# COMMUNITY BOARD FEEDBACK PACKAGE

**Business Name:** Don Giovanni Ristorante

**Cafe Address:** 358 W 44TH ST, NEW YORK, NY, 10036

**Application Number:** 20240719010016

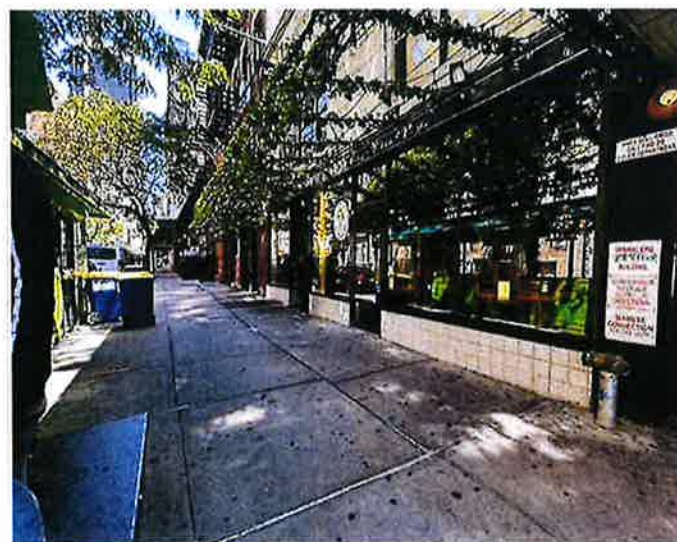
The proposed Site Plan has inaccurate measurements that are significantly larger than the actual cafe space. The applicant has provided the attached Revised Site Plan with accurate measurements and a corresponding reduction in the number of tables and seats.

MCB4 requests that the proposed site plan be revised to reflect accurate measurements and that the number of tables and seats be reduced as necessary to fit within the smaller cafe perimeter. Applicant has agreed to these modifications and has provided the attached Revised Site Plan.
